HISTORIC AND DESIGN REVIEW COMMISSION

HDRC CASE NO: 2016-319
ADDRESS: 1300 GUADALUPE ST
LEGAL DESCRIPTION: NCB 2444 BLK 1 LOT 19 AND 20
ZONING: C3 HL
CITY COUNCIL DIST.: 5
LANDMARK: Null
APPLICANT: Debra Dockery
OWNER: Guadalupe Cultural Arts Center
TYPE OF WORK: Window and door replacement
REQUEST:

GUADALUPE CULTURAL ARTS CENTER FORMER PROGRESO PHARMACY RENOVATION

SOUTH ELEVATION - WINDOWS
SEE SHEET A3.1 FOR WINDOW SCHEDULE

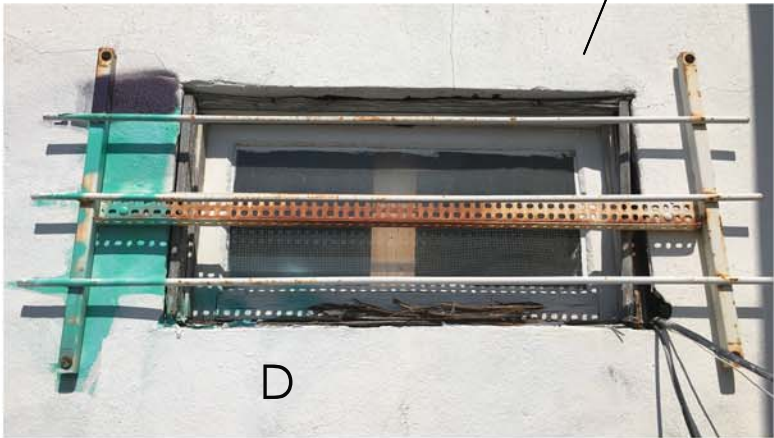
ALL D WINDOWS ARE WOOD AWNING WINDOW. THERE IS WOOD ROT ON BOTH OF THESE WINDOWS. STEEL BARS HAVE BEEN PLACE TO KEEP VANDALS OUT. IT IS PRPOSED TO REPLACE THESE WINDOWS WITH WOOD WINDOWS, AND REMOVE THE STEEL BARS.

WINDOWS K ARE WOOD FRAMED WINDOWS WHERE THE GLASS HAS BEEN BROKEN AND MUCH OF THE WOOD IS ROTTED OR BROKEN. THE OPENING HAS BEEN BOARDED WITH PLYWOOD AN STEEL GUARDS HAVE BEEN PLACED TO KEEP VANDALS OUT. IT IS PROPOSED TO REPLACE THE WINDOW WITH WOOD FRAMED WINDOWS TO MATCH EXISTING/ HISTORIC CONDITIONS AND TO REMOVE THE STEEL GUARDS.

WINDOW D APPEARS TO HAVE BEEN A WOOD AWNING WINDOW. STEEL GUARDS HAVE BEEN PLACED TO KEEP VANDALS OUT. IT IS PRPOSED TO REPLACE THIS WINDOW WITH A FIXED WINDOW TO MATCH EXISTING/ HISTORIC CONDITIONS AND TO REMOVE THE STEEL GUARDS.

DOOR 108 HAS BEEN REMOVED AND BOARDED WTIH PLYWOOD. IT IS PROPOSED TO REPLACE THIS DOOR OPENING WITH A HOLLOW METAL DOOR AND FRAME.
